Model (s) affected: RV-3

PURPOSE: To specify airframe alterations required on VAN'S AIRCRAFT RV-3 airplanes for re-designation to model RV-3A for the purpose of exempting them from the limitations dictated by FAA GENOT RWA 1/40 SVC B, dated Mar. 24, 1981. Said GENOT requires that airworthiness certificates of all RV-3 aircraft be suspended until new ones are issued which prohibit aerobatics. Said aerobatic prohibition is permanent, and will be applicable to all aircraft designated VAN'S AIRCRAFT RV-3.

STRUCTURAL CHANGES:

REAR SPAR ATTACH MODIFICATION
MODEL: RV-3/RV-3A DR: R. YANGRUSVEI

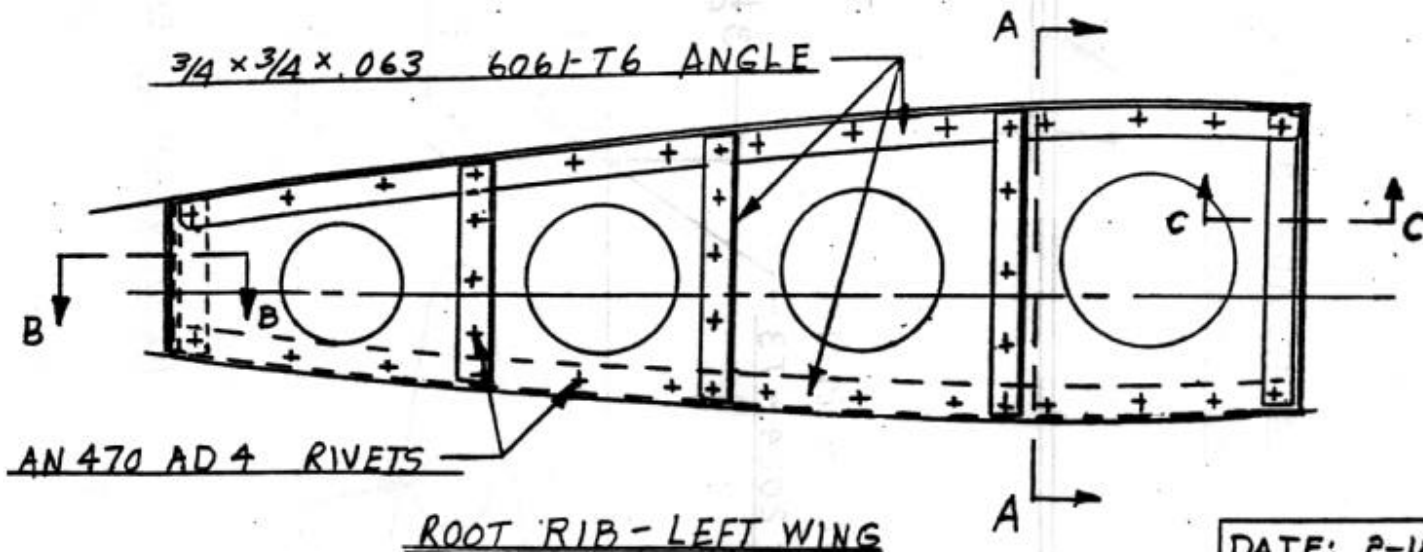
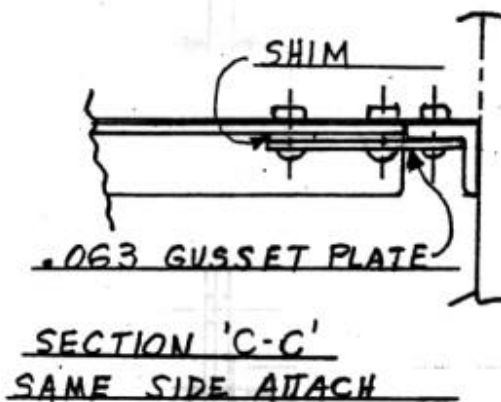
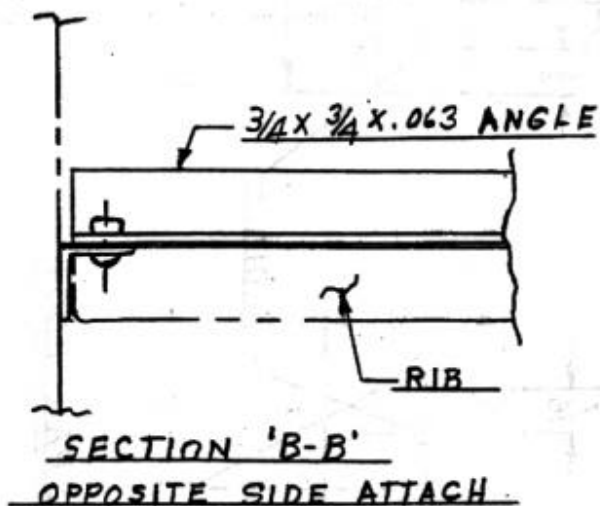
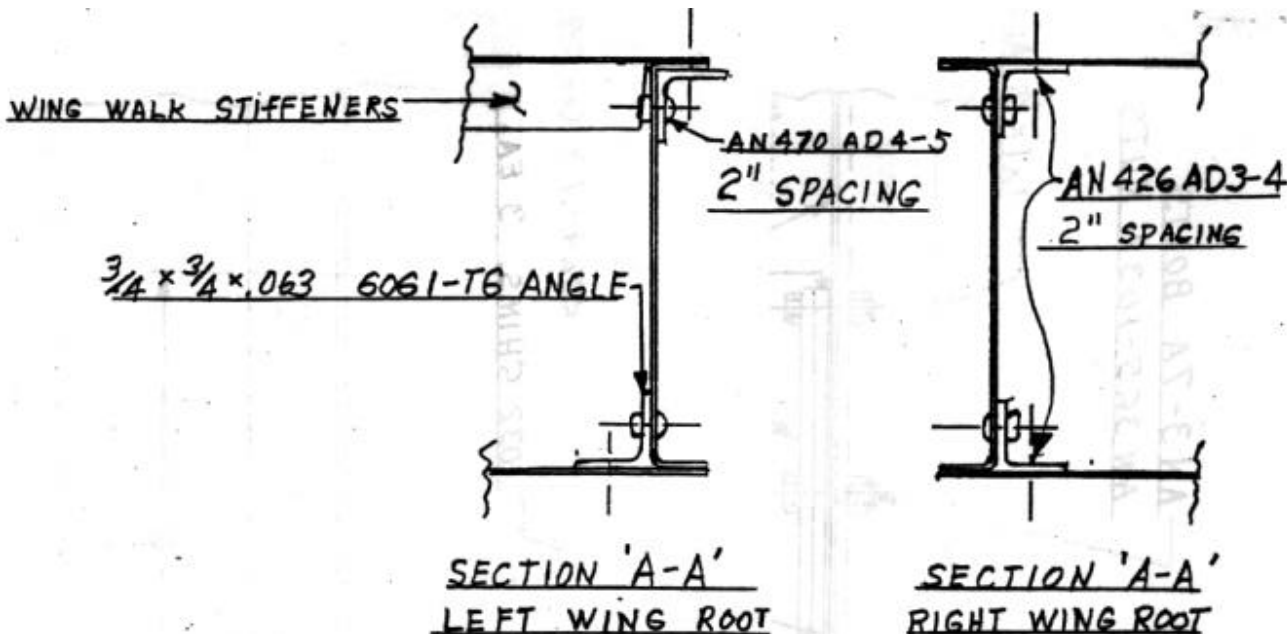
CN-1-1 details rear spar and center section modifications for RV-3s built from plans and kits supplied before Sept. 1980. These are distinguished by rear spar center sections of 1 x 1 x 1/8" 6061-T6 angle.

RV-3 plans and kits supplied before Sept. 1981 have a rear spar center section made of 1 x 1 x 1/8 6061-T6 aluminum angle. This modification, per CN-1-1, requires that a doubler plate be added to the outboard ends of the center section. For completed airplanes, accomplishing this will require that part of the seat skin be drilled free and bent up for access, and that a larger hole be cut in the fuselage skin for this member. The three outboard most rivets on each side are to be drilled out and replaced by AN3 bolts. The reason for this is that they are both easier to replace and stronger than the original rivets. Along with this, the rear spar root plate must have a doubler plate riveted to it.

VAN'S AIRCRAFT DWG # C.N.I.-3

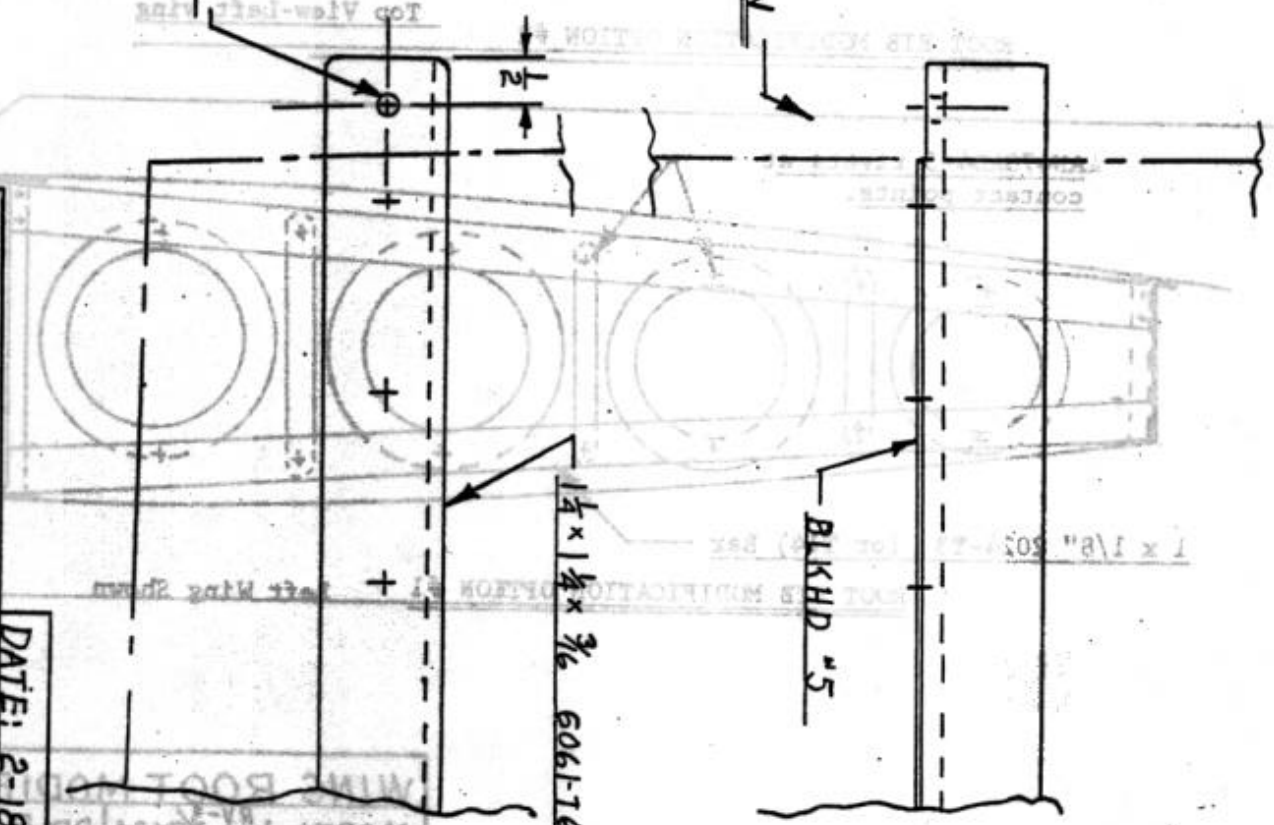
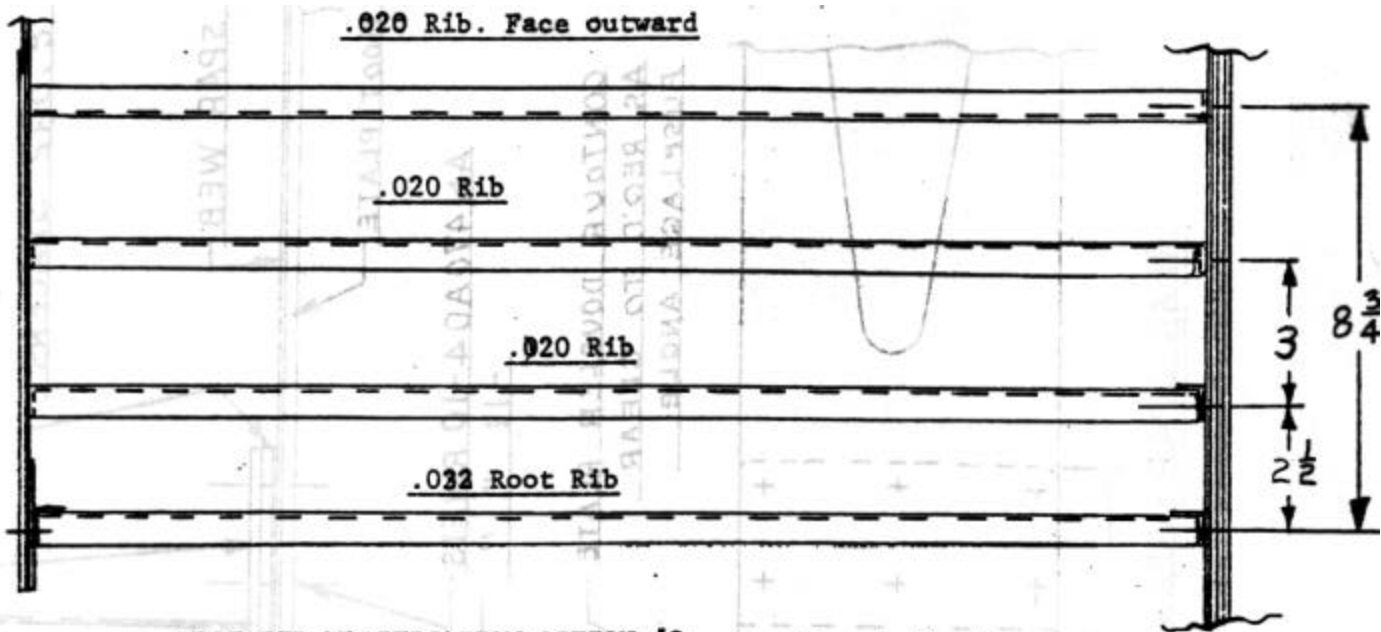
CN-1-3 details rear spar and center section modifications for RV-3s built from plans and kits supplied after Sept. 1980. These are distinguished by rear spar center sections of 1½ x 1½ x 3/16" 6061-T6 aluminum angle.

For RV-3 plans and kits supplied after Sept. 1980, a heavier center section spar was provided. (1 1/2 x 1 1/2 x 3/16 6061-T6 angle) This member needs no reinforcement, but the rear spar root plate must be modified per CN-1-3 to place the bolt in double shear. Modification of the rear spar root should be done in conjunction with the root rib modifications detailed on CN-1-2 and CN-1-4.

WING ROOT MODIFICATION	
MODEL: RV-3/RV-3A	DR: R. VAN GRUNSEN
VAN'S AIRCRAFT DWG: CN-1-4

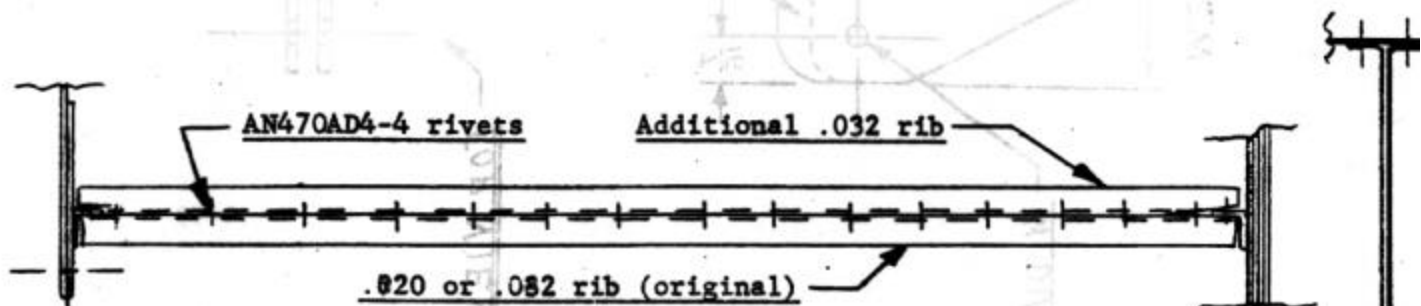
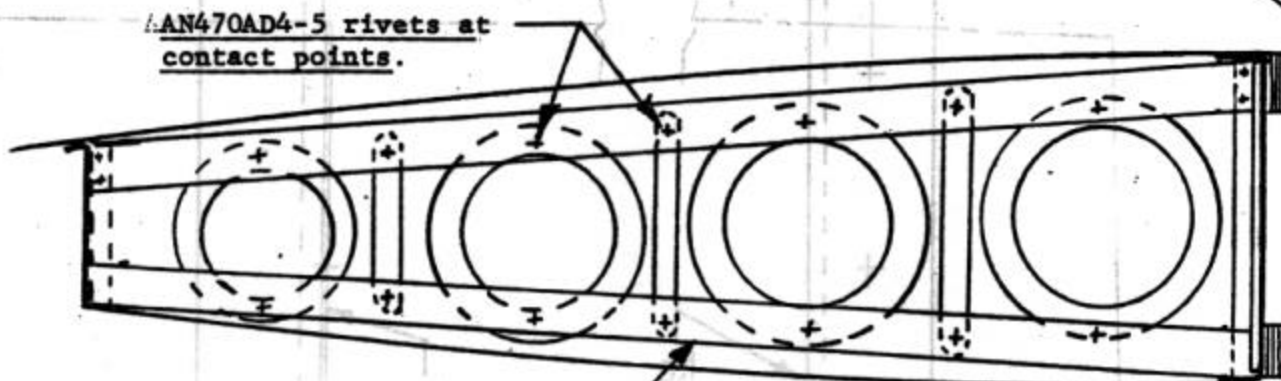
CN-1-4 details wing root rib modifications which can be performed on RV-3s of varying vintages. Option #1 applies to all vintages or degrees of completion. Option #2 and #3 apply to new RV-3 construction projects and to all inprogress RV-3 wings which have not yet had the final (top) skins riveted on.

Options #2 and #3 are suggested for modifications being done on wings in early stages of construction, or at least those being done before the final (top) wing skins is riveted on. Of these, Option #3 is probably the best because it more effectively stiffens the skin of the inboard wing, and also permits the builder to simplify wing walk construction.
